Revised urban design plans and memorandum

Ref: 2023_084 Greene Mt Iron Junction Minute 7 Response_A

**MT IRON JUNCTION FAST TRACK – SECTION 67 REQUEST FOR FURTHER
INFORMATION – RFI RESPONSE**

MT IRON JUNCTION, WĀNAKA, 9382 (LOT 6 DP 605028, LOT 2 DP 60502, LOT 3 DP 359869)

SHADE STUDY - WINTER SOLSTICE 21st JUNE

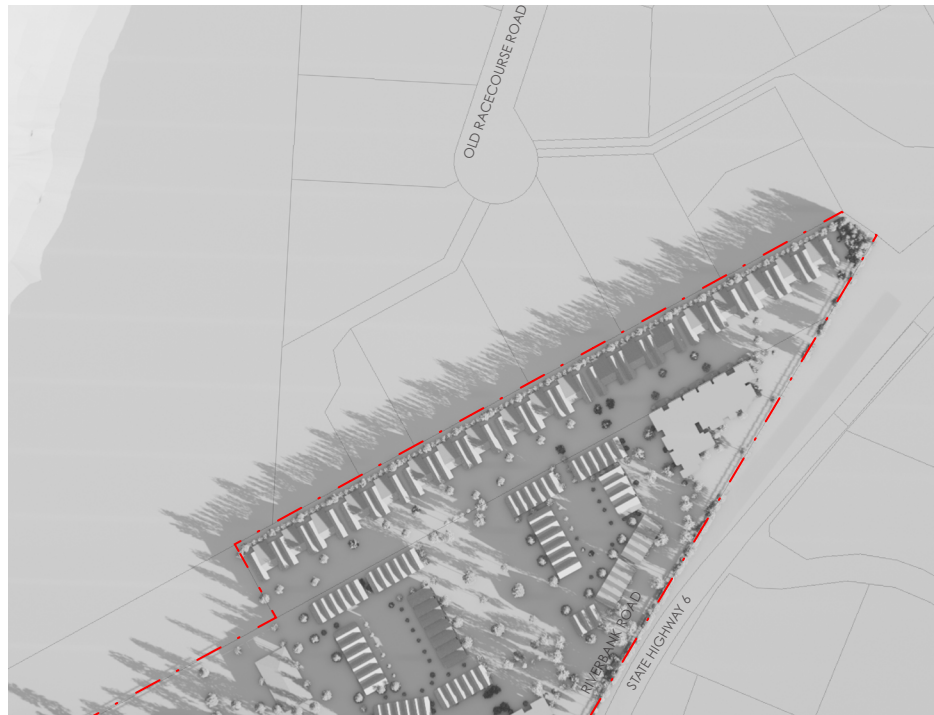
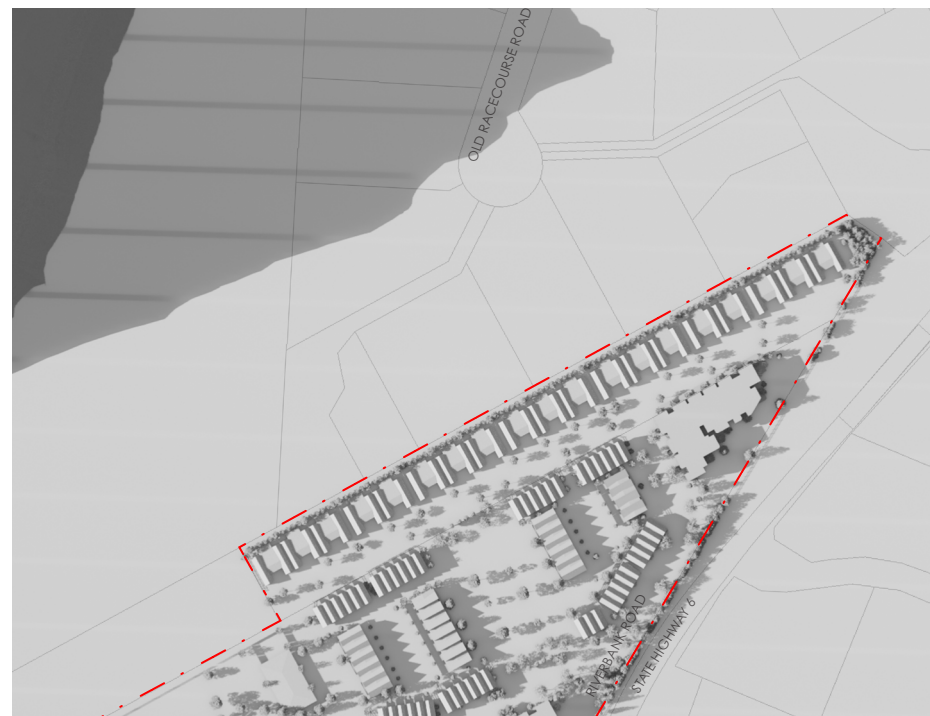
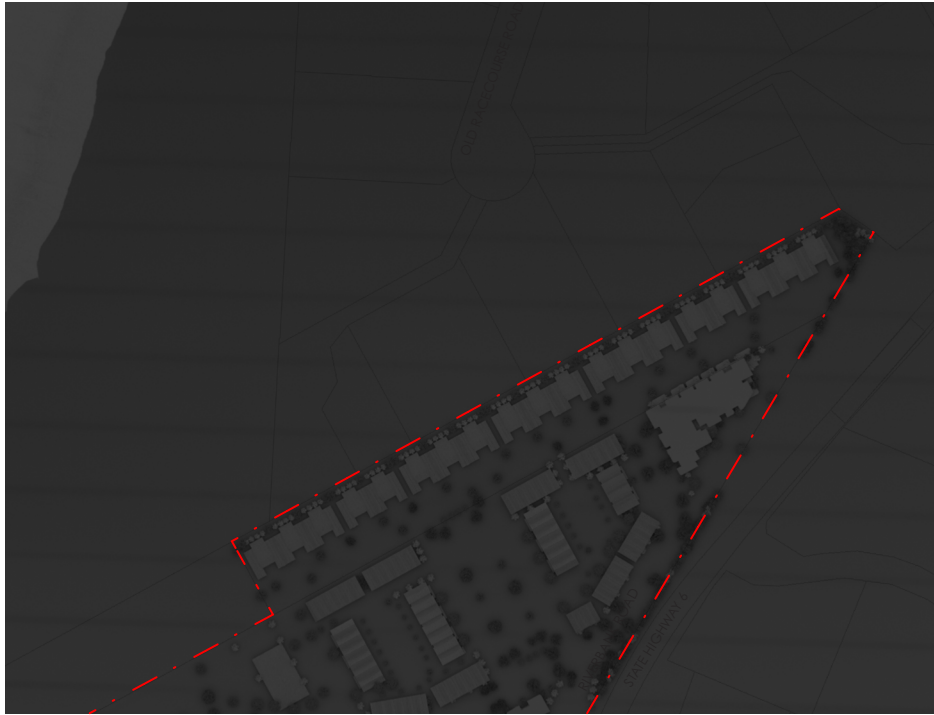
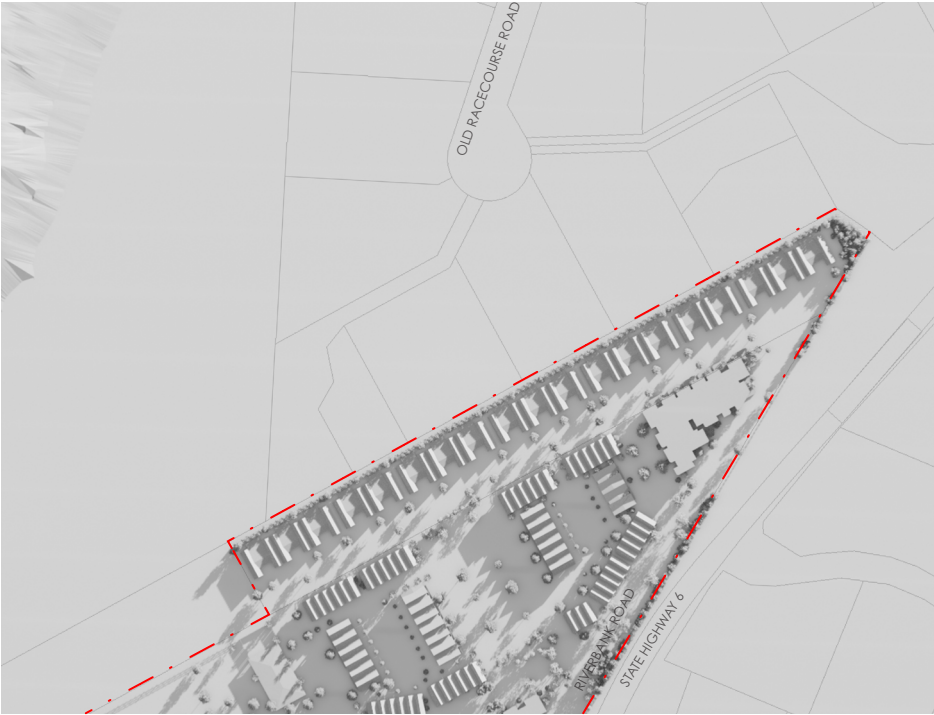
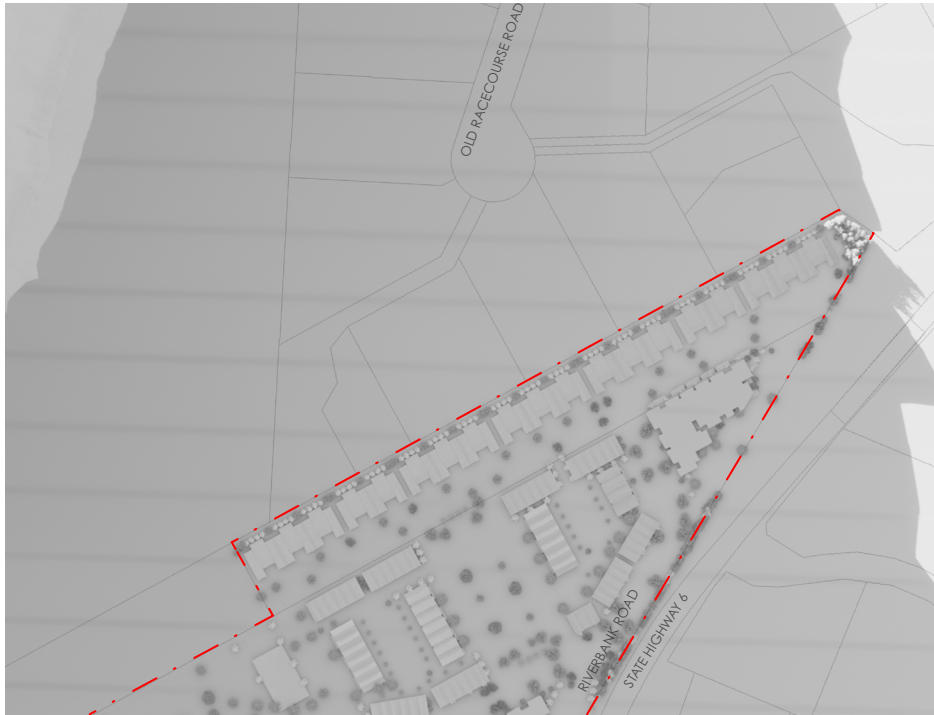
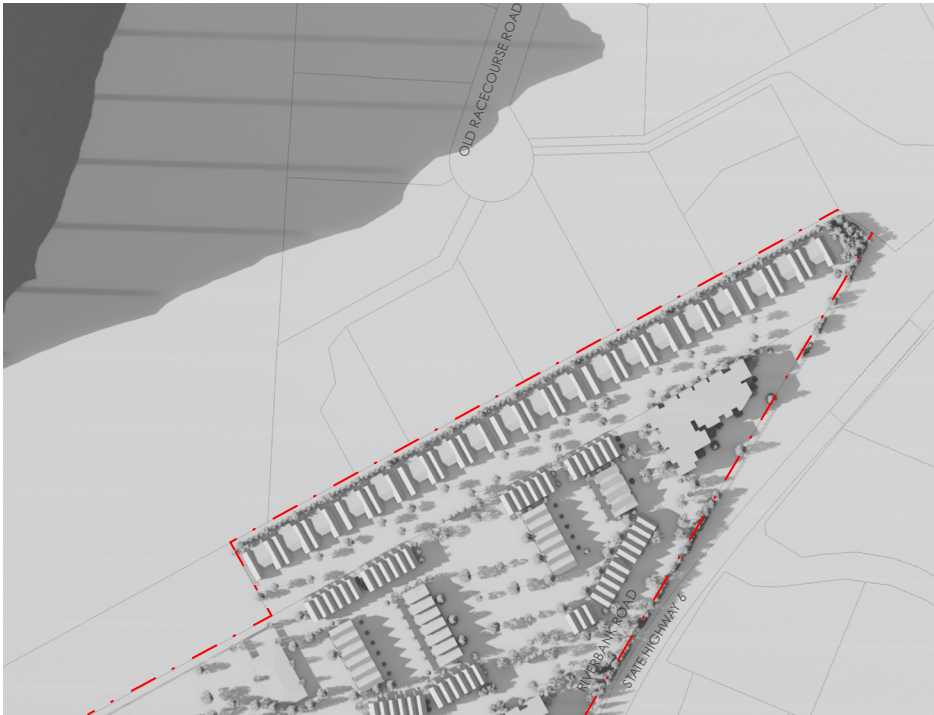
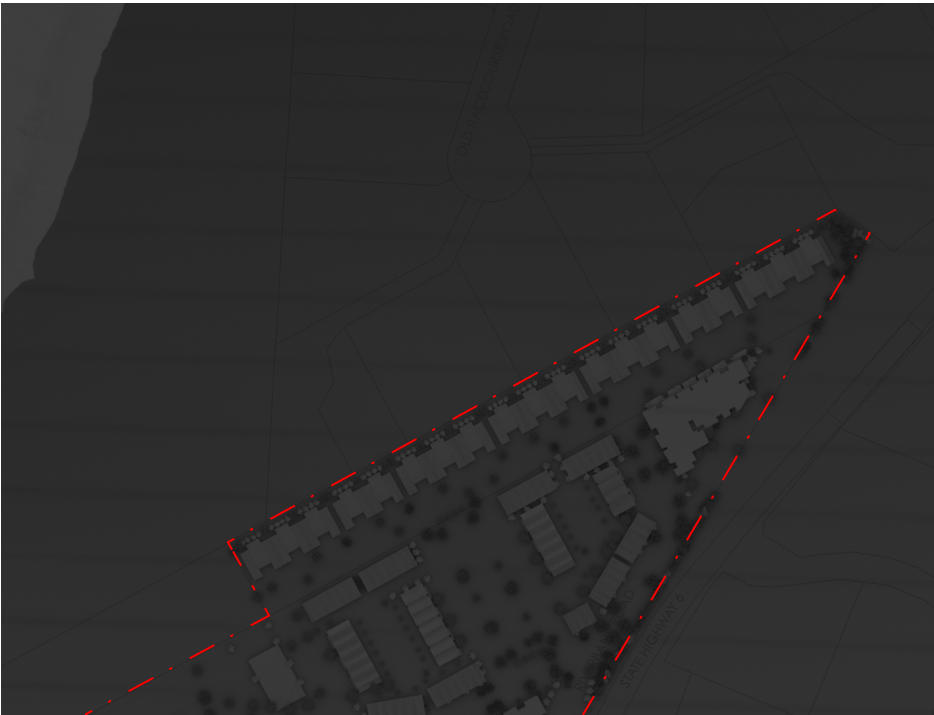
Updated shading diagrams have been prepared for the revised single-storey layout and proposed boundary planting (refer to DCM Minute 7 Graphic Attachment) to illustrate the potential shading effects of the proposed trees along the Old Racecourse Road. As the trees are located along the southern boundary of the neighbouring properties, their proposed height is not expected to result in significant additional shading. Shadows will generally fall towards the development site, with only limited shading of the neighbouring properties occurring during the morning and evening during the summer when the sun is at a lower angle. These effects are minor and limited in duration, while the proposed trees provide screening and softening of the built form along the boundary.

B. BACK YARD TO OLD RACECOURSE ROAD INTERFACE PERSPECTIVE - TYPOLOGY A (NEW)

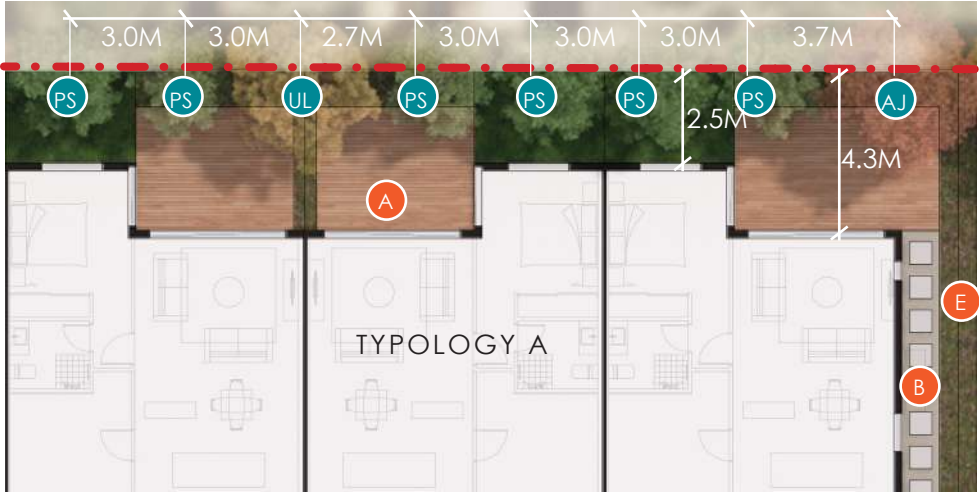
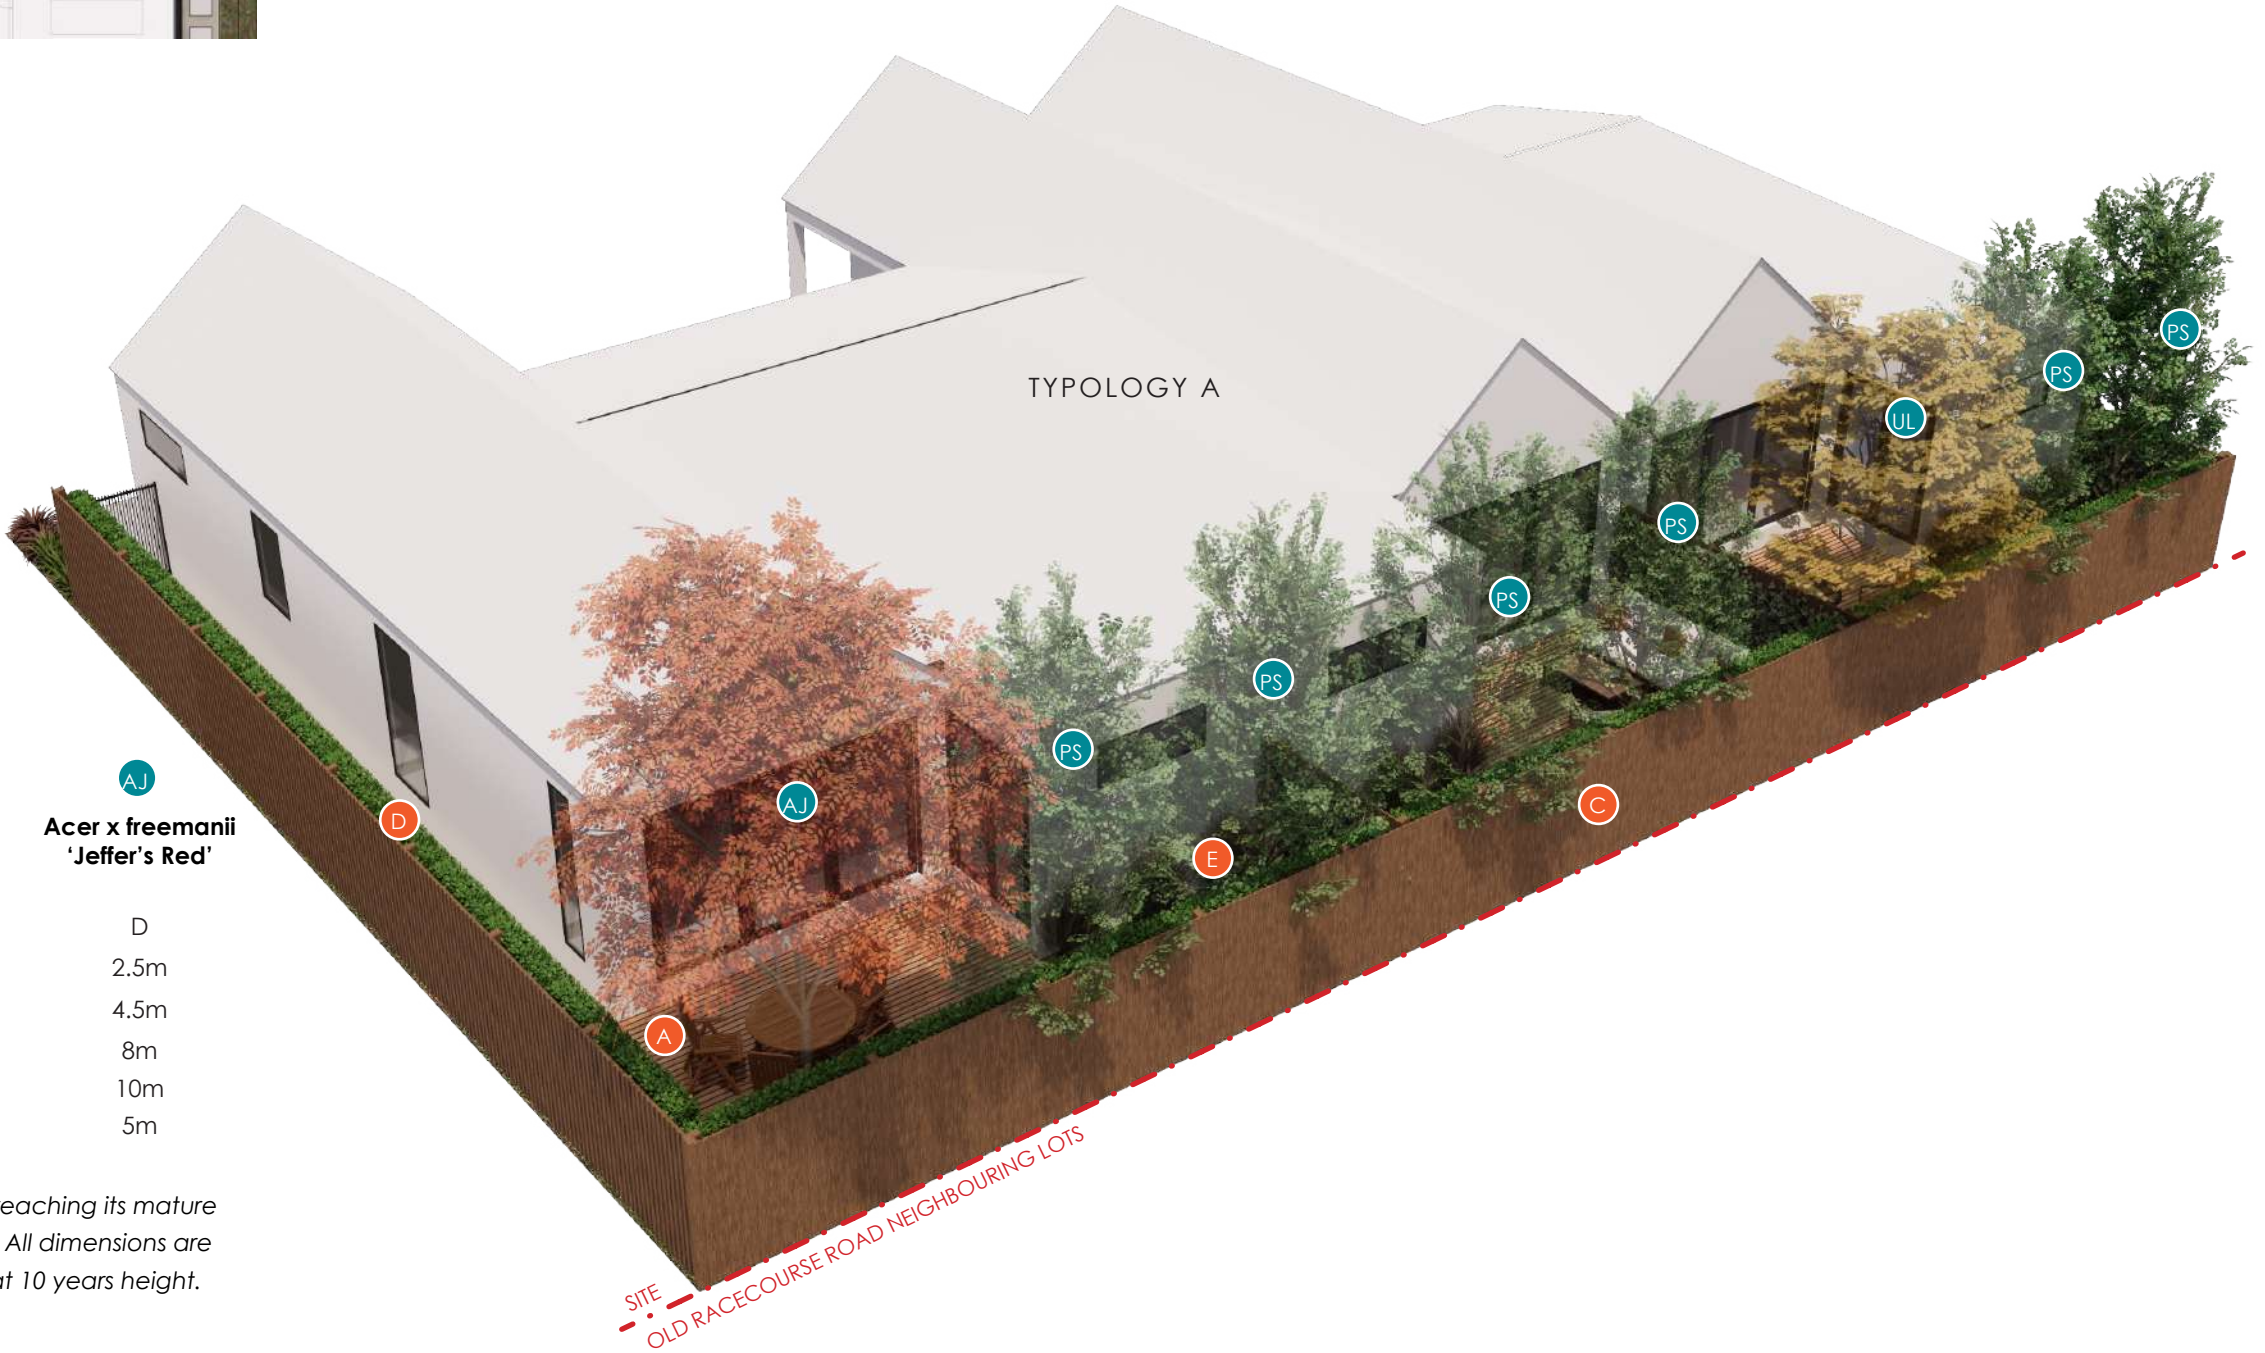
- All upper-level rooms and windows have been removed from the Old Racecourse Road interface, removing the potential for overlooking from upper levels;
- The overall height and scale of the built form experienced from the neighbouring properties is reduced;
- The visible building profile above and through the boundary treatment and planting is reduced;
- The potential extent and duration of shading from the proposed buildings is reduced; and
- A consistent single-storey edge is provided along the full length of the common boundary

The remaining 12 Typology B dwellings along the Old Racecourse Road boundary have been replaced with Typology A dwellings. As a result, all dwellings adjoining this boundary are now Typology A and the built form along the full length of the interface is single-storey (refer to DCM S67 Graphic Attachment revision B, dated 13/08/2026).
